service bulletin

No. 89-15

Installation of Dual Engine Console Mount Commander Remote Controls 88688A22, 88688A23 and 88688A24

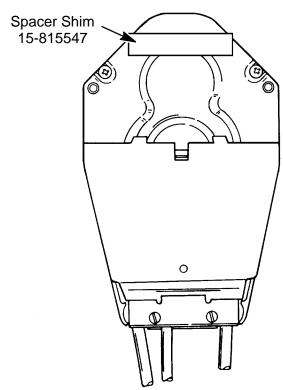
In some cases the hand grips of the dual engine console mount controls will interfere with each other in the neutral position. This condition can usually be corrected by putting a shim between the two controls using spacer shim part number (15-815547 ordered separately). Attach the self adhesive shim to the aluminum backing plate of one of the controls as shown in the diagram following. Controls must be partially removed from console to install spacer shim.
